ADDENDUM #3

DATED: AUGUST 13, 2025

**PROJECT: Huxford Elementary School Gymnasium
And Classroom Addition For
Escambia County Board Of Education
Huxford, Alabama**

PH&J No: 2312SC

PARTIAL ENLARGED PLAN - ARCHERY RANGE 331 / SHELTER

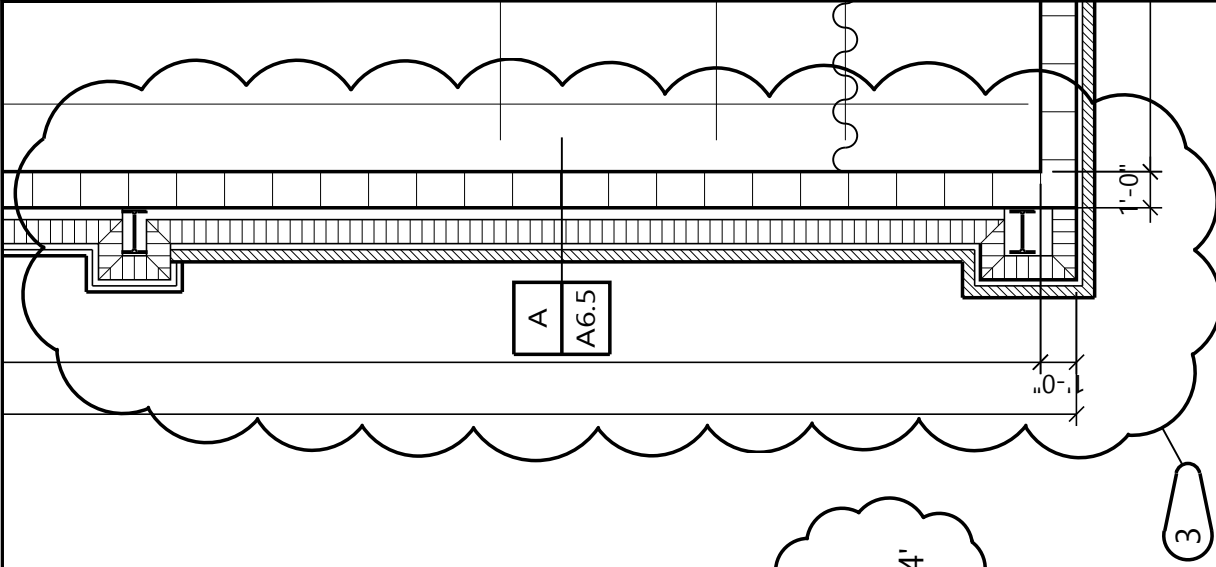
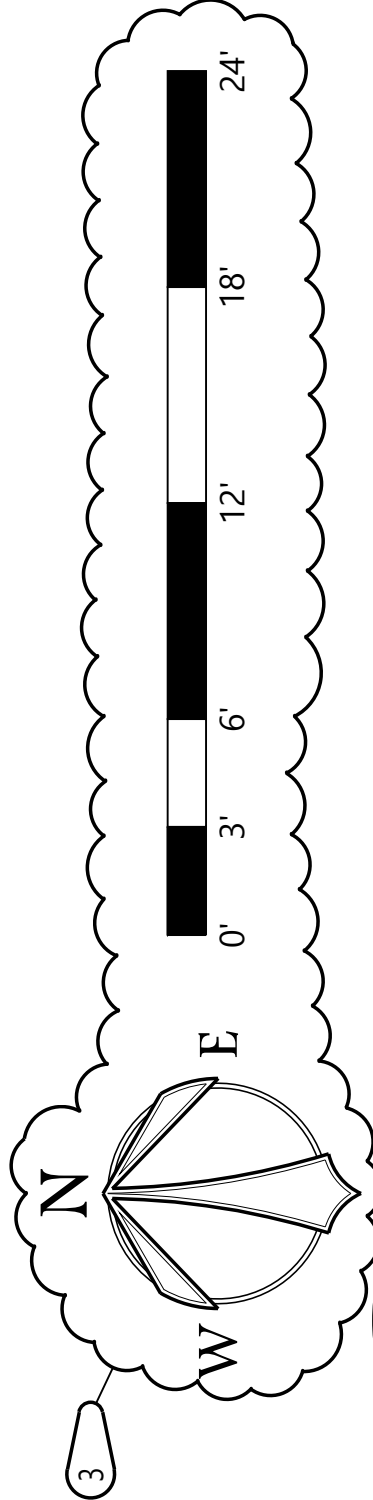
“BOOK DETECTION SYSTEM BY OWNER”
4. **Enlarged Floor Plan – Archery Range 331/Shelter (Sheet A2.5)**: revise the Southwest corner of the exterior wall as shown in the sketch contained herein as Addendum No.: 3; Attachment #3.
5. **Teaching Desk (Sheet A2.6)**: Elevation mark for the teaching desk in Lab 320 should read AA/A7.3. Delete the southern callout.

DRAWN:	SRH
CHECKED:	HGG
DATE:	07.30.25
REVISED:	
SHEET TITLE:	LOBBY 300 REFLECTED CEILING PLAN
PSCA #:	9551
DCM #:	2023650
PHJ #:	2312SC
JOB NO.:	
SEQ. NO.:	1 OF 1
SHEET NO.:	
ADD3	
ATTACHMENT #4

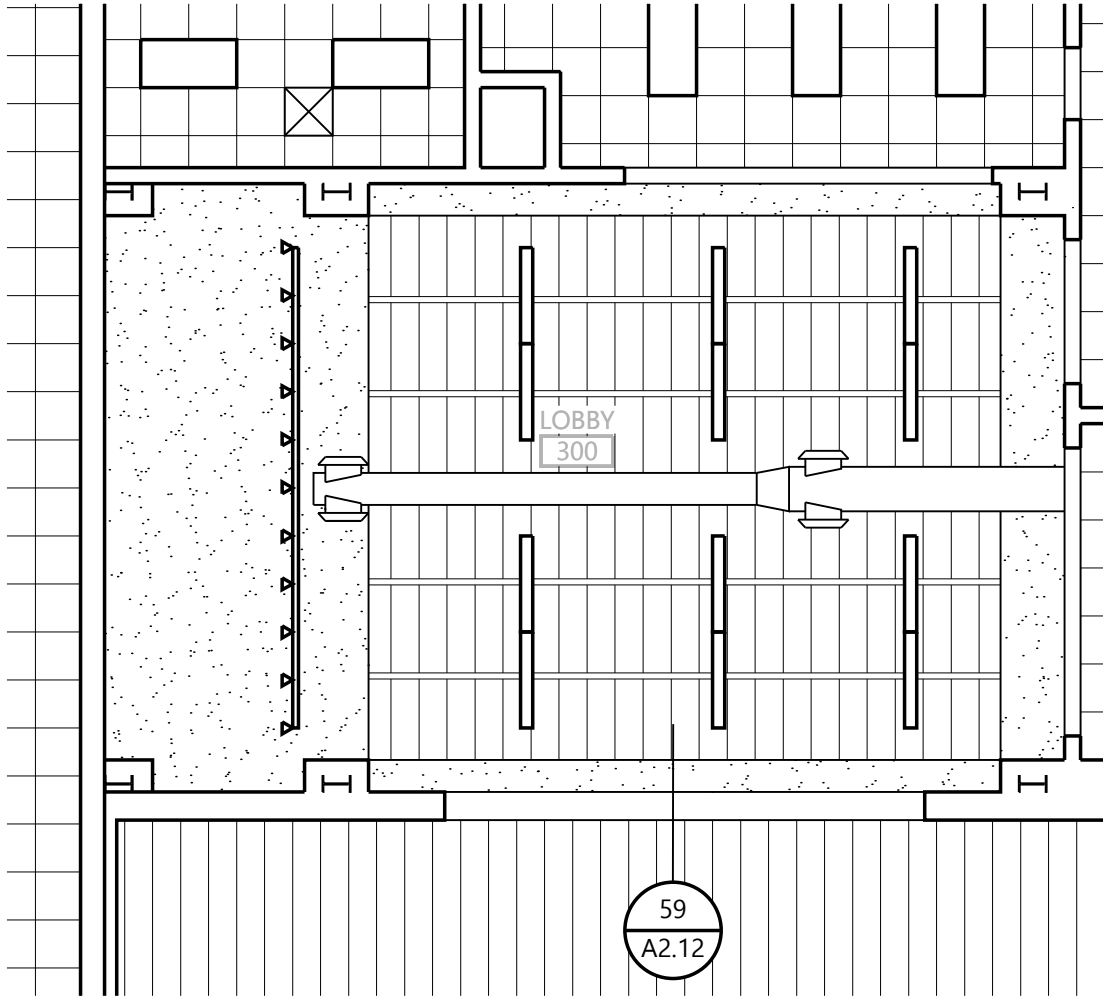
7. **Lobby 300 Reflected Ceiling Plan (Sheet A3.2)**: Revise the Reflected Ceiling Plan with the sketch contained herein as Addendum No.: 3; Attachment #4.

8. **Lobby 300 Reflected Ceiling Plan (Sheet A3.4)**: Revise the Reflected Ceiling Plan with the sketch contained herein as Addendum No.: 3; Attachment #4.

ADDENDUM NO.: 3
ATTACHMENT #5

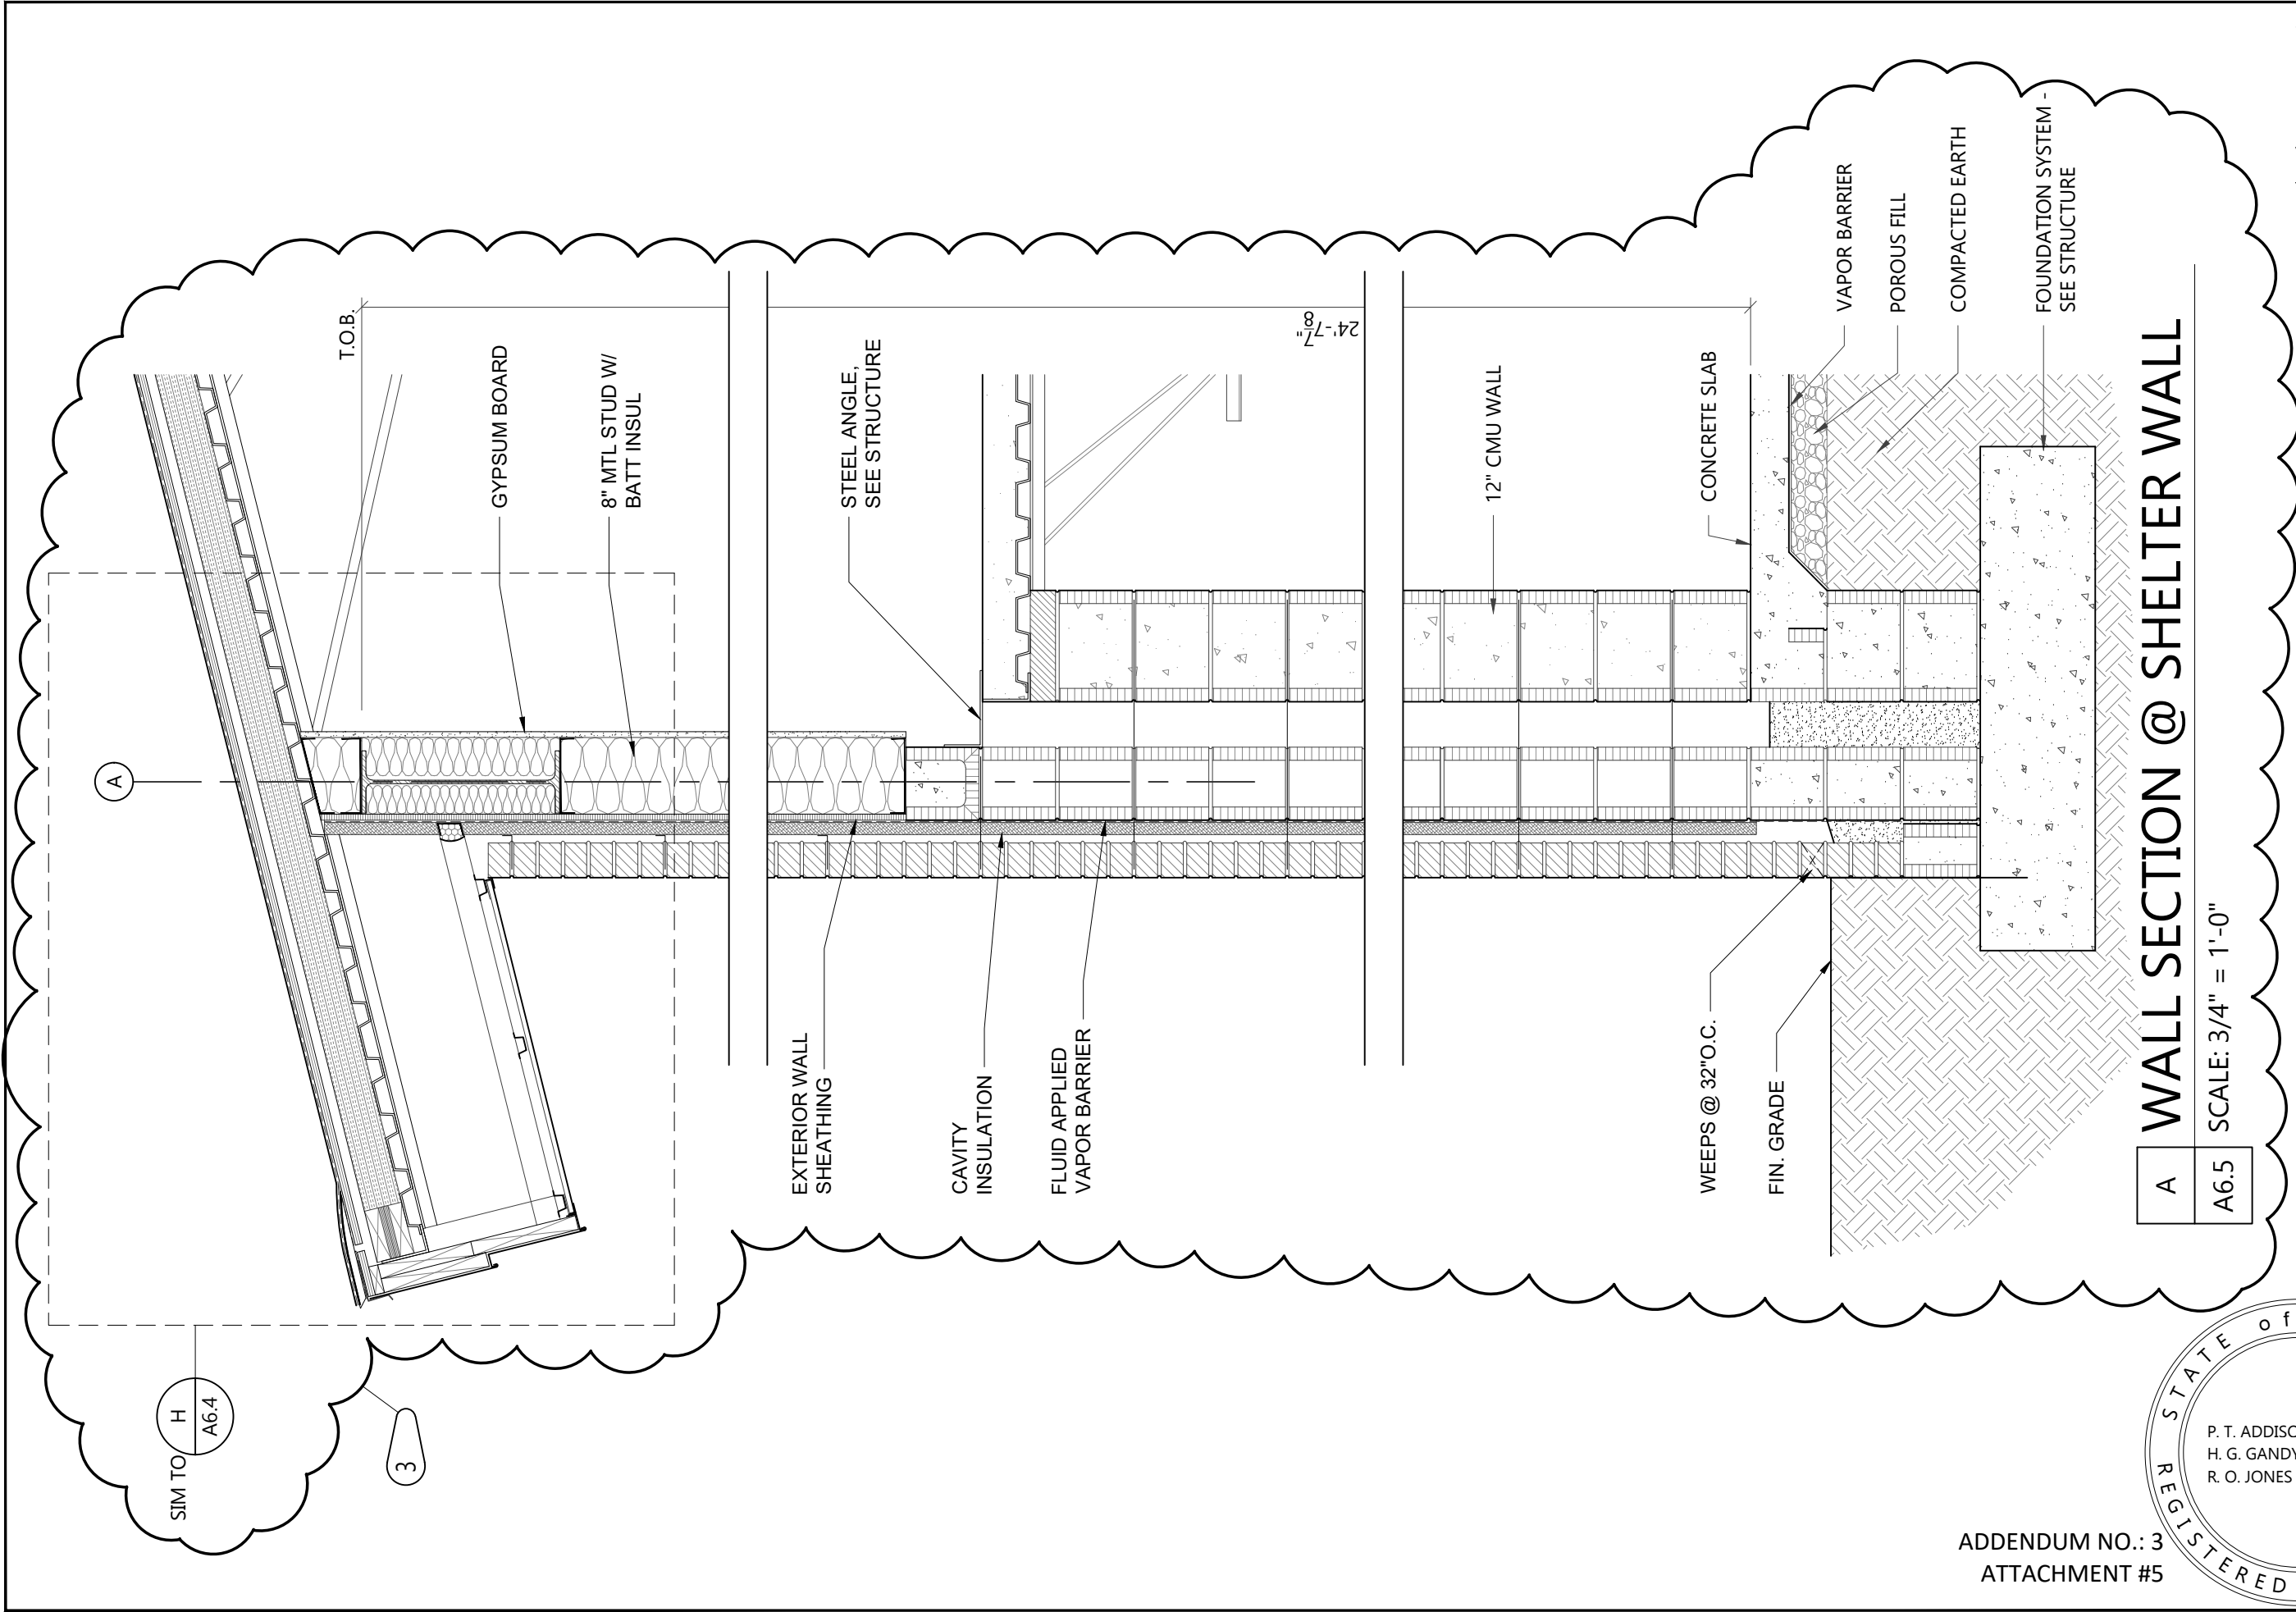
9. **Wall Section (Sheet A6.5)**: Add the Wall Section A6.5 as shown in the sketch contained herein as Addendum No.: 3; Attachment #5.
10. **Typical Desk Elevations (Sheet A7.3)**: Delete the reference of quantities for Detail Z/A7.3.

PARTIAL FOUNDATION PLAN
SCALE: 1/8" = 1'-0"

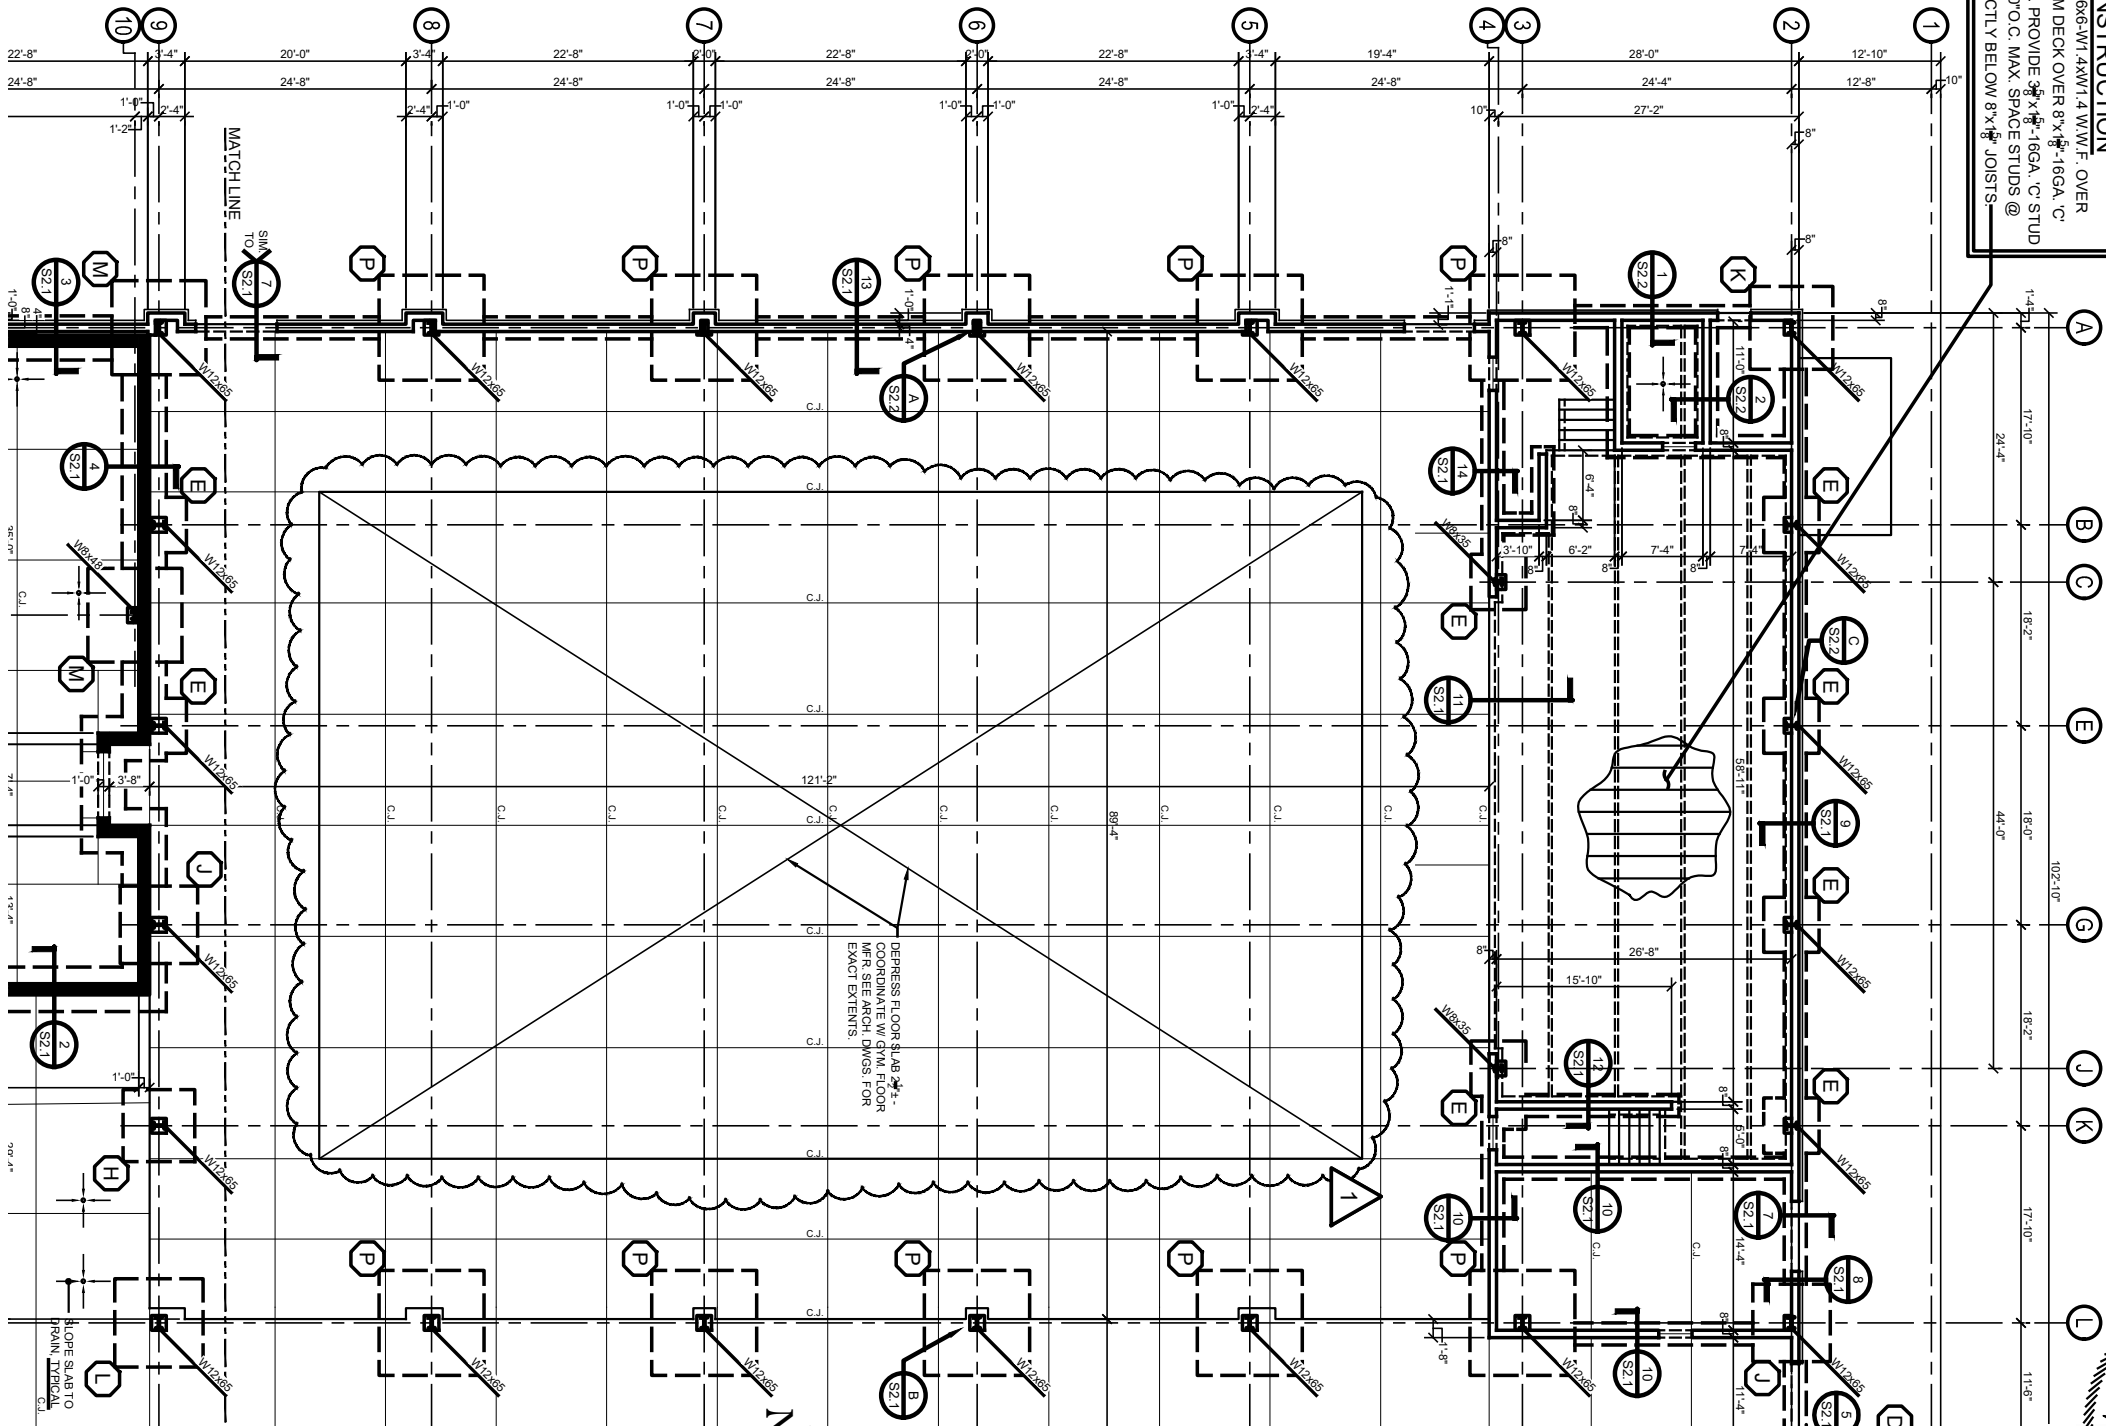
12. **Stage Curtain Detail (Detail 6/A8.1)**: Delete reference to "Scalloped Valence". The Valence shall be square across the proscenium opening.
13. **Foundation Plan (Sheet S1.1)**: Revise the partial floor plan as shown in the sketch contained herein as Addendum No.: 3; Attachment #6. Coordinate the dimensions with those shown on the Architectural Sheets.

PLATFORM CONSTRUCTION
3" CONCRETE SLAB W/ 8x6-W/1.4 W.W.F. OVER
9/16"-28GA. STEEL FORM DECK OVER 8"x18"-16GA. 'C'
STUD JOISTS @ 16" O.C. PROVIDE 3/8"x1/2"-16GA. 'C' STUD
SUPPORT WALLS @ 8'-0" O.C. MAX. SPACE STUDS @
16" O.C. & LOCATE DIRECTLY BELOW 8"x18" JOISTS

SECTION 11
N.T.S.

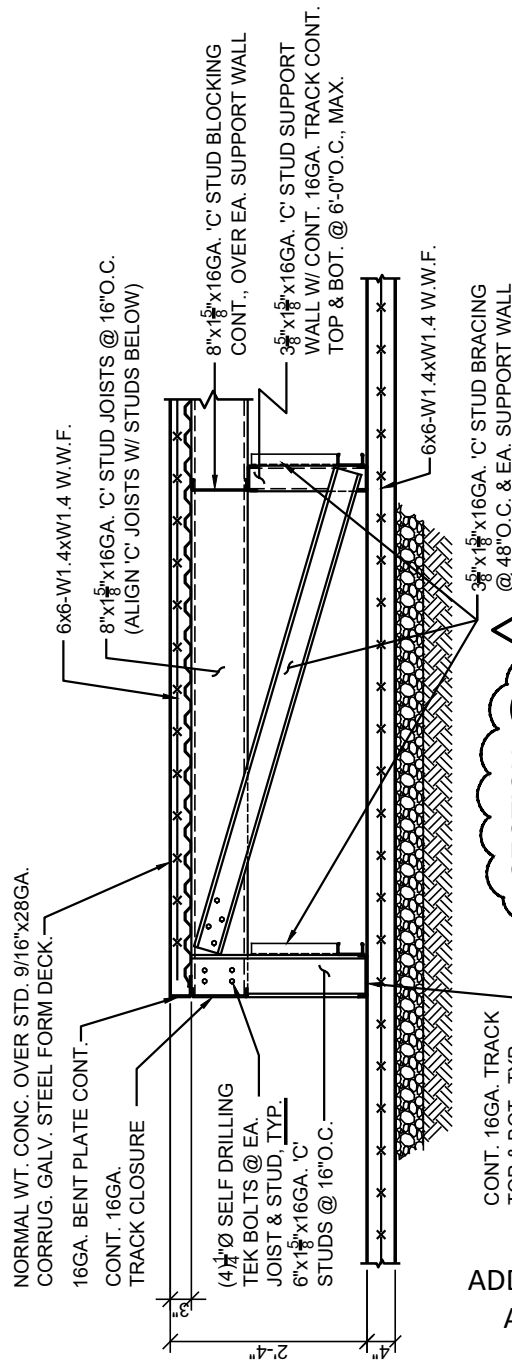
14. **Section Detail (Sheet S2.1)**: Revise Detail 4/S2.1 as shown in the sketch contained herein as Addendum No.: 3; Attachment #6.
15. **Section Detail (Sheet S2.1)**: Revise Detail 11/S2.1 as shown in the sketch contained herein as Addendum No.: 3; Attachment #6.

SECTION

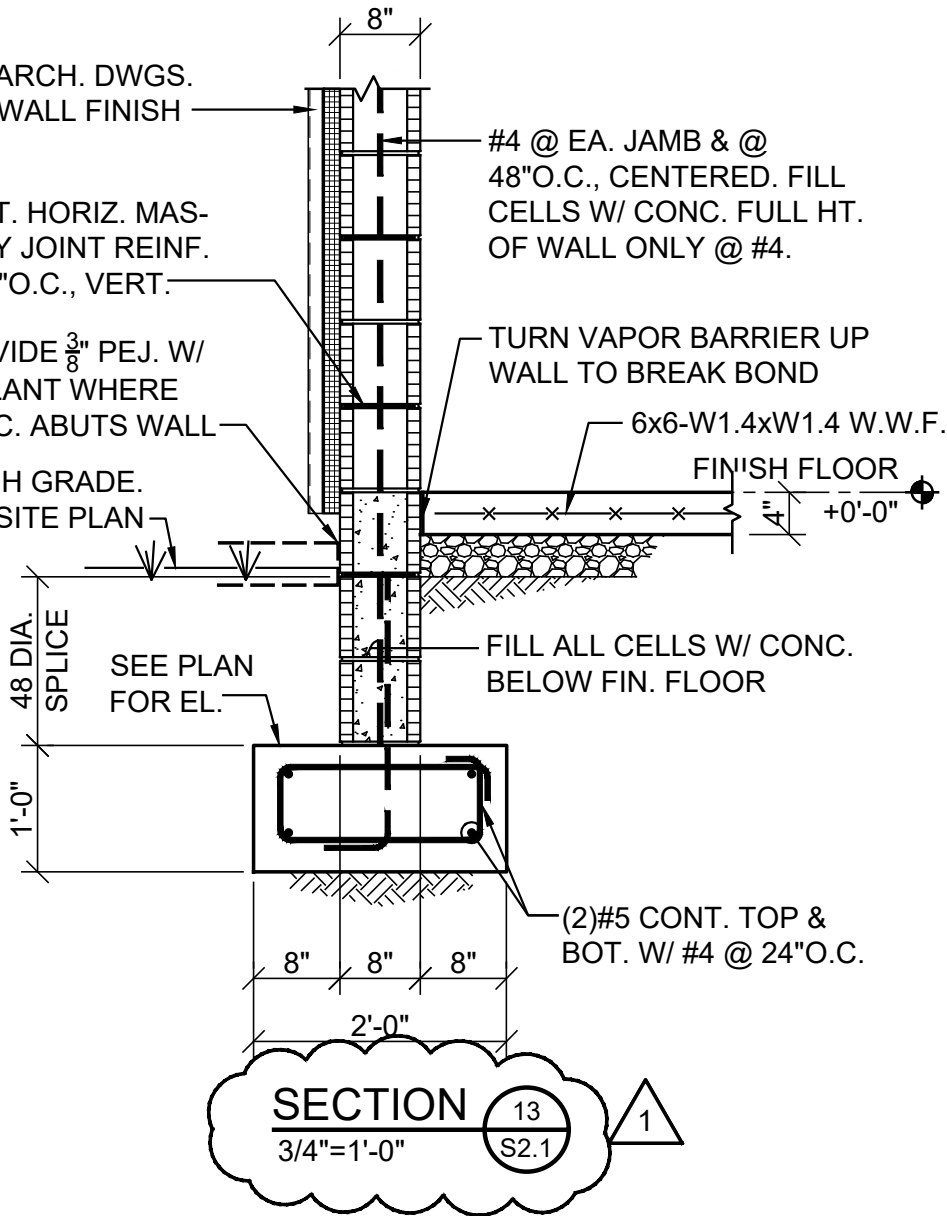
16. **Section Detail (Sheet S2.1)**: Revise Detail 13/S2.1 as shown in the sketch contained herein as Addendum No.: 3; Attachment #6.
17. **Section Detail (Sheet S2.1)**: Revise Detail 14/S2.1 as shown in the sketch contained herein as Addendum No.: 3; Attachment #6.

SEE ARCH. DWGS.
FOR WALL FINISH

CONT. HORIZ. MAS-
ONRY JOINT REINF.
@ 16"O.C., VERT.

PROVIDE $\frac{3}{8}$ " PEJ. W/
SEALANT WHERE
CONC. ABUTS WALL
